Technical Bulletin

TB 0303 – Substation Access Roads & Driveway Design Review

Figure 1 - A typical zone substation entry access road

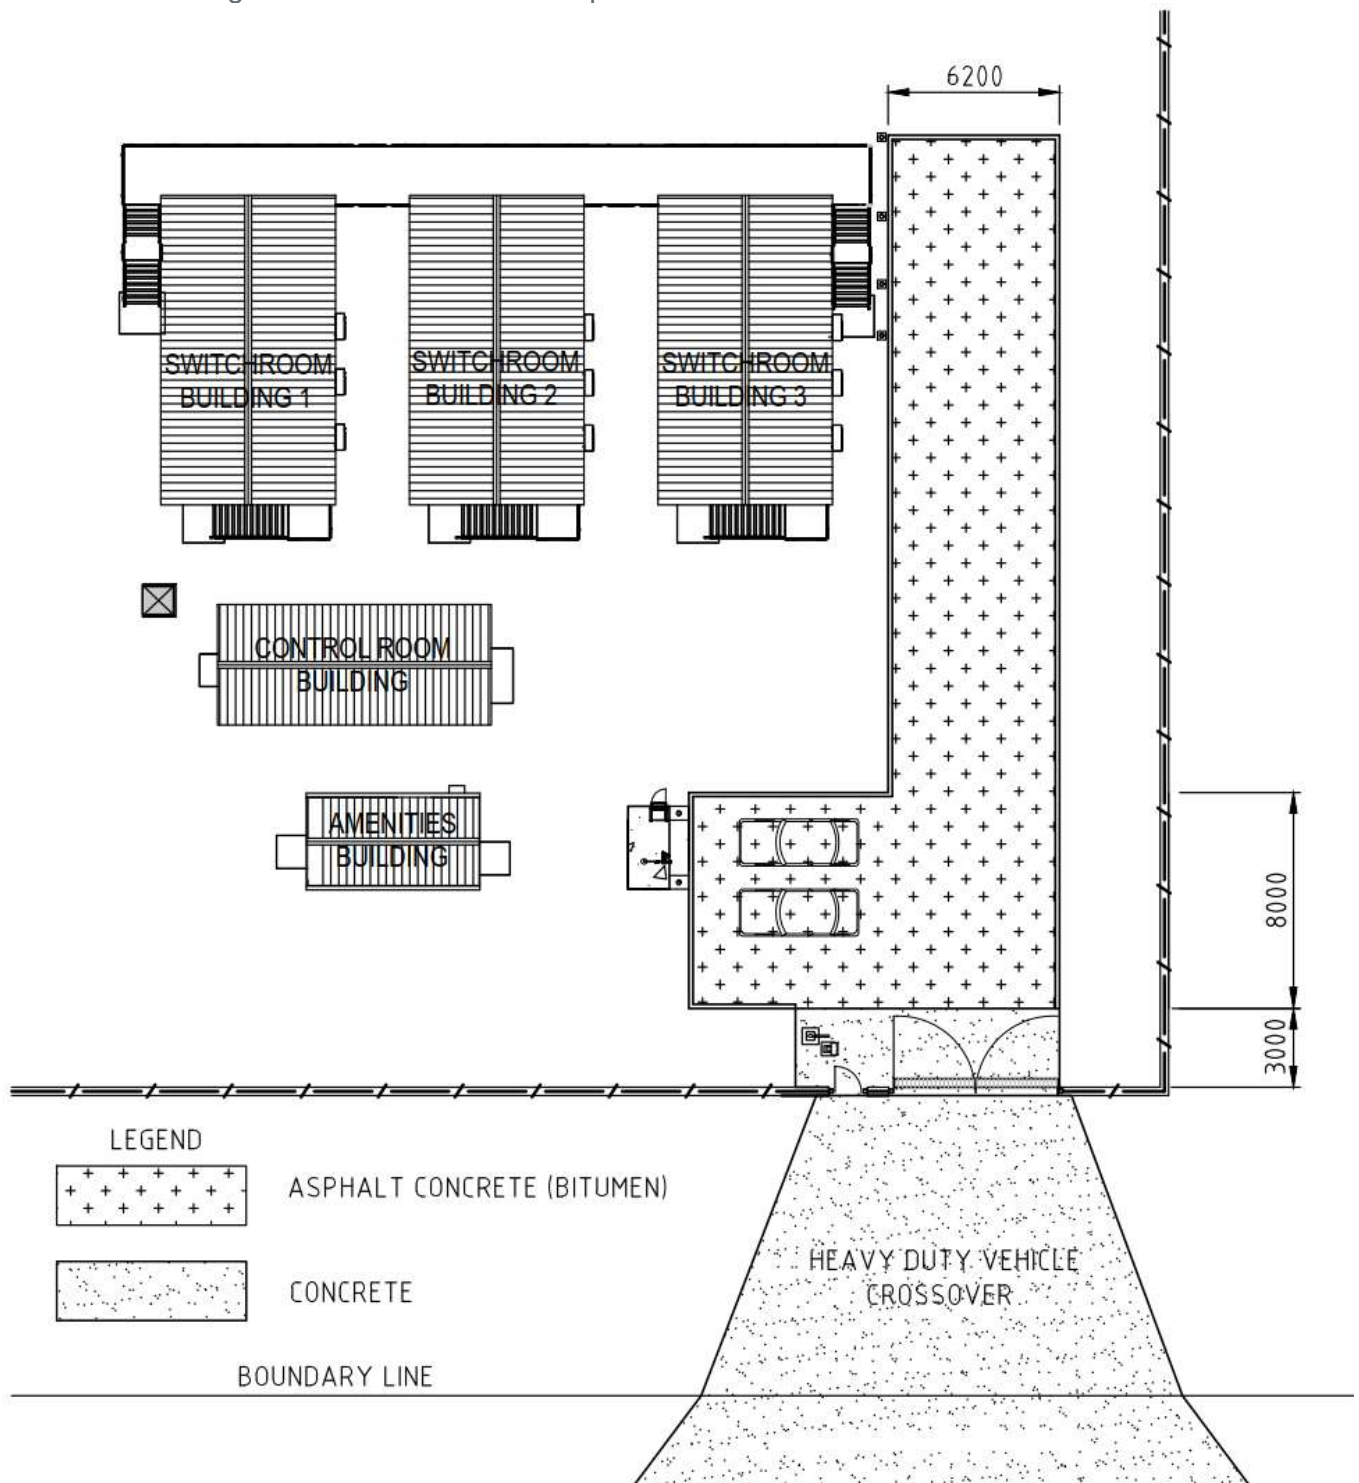
Concrete will be retained for the section of driveway between the public road and the zone substation security fence (the crossover). The concrete pavement will extend approximately 3m inside the substation security fence.

Where the driveway is subjected to high traffic movements, the construction will be asphaltic concrete (bitumen). This includes the area adjacent to the substation entry gate and substation buildings. The new design includes an asphalt landing pad (approximately 8m x 12m) adjacent to the substation entry gate to allow for vehicle parking and an equipment set-down area.

Where the driveway extends further into the substation yard and won't be subjected to high traffic movements, the driveway construction will be 20mm diameter single aggregate laid to a depth of 100mm over a specified base course and sub-base. The aggregate driveway construction is not appropriate for high traffic movement areas as the gravel may become displaced. Asphaltic concrete should be used in locations where high traffic movements are expected.
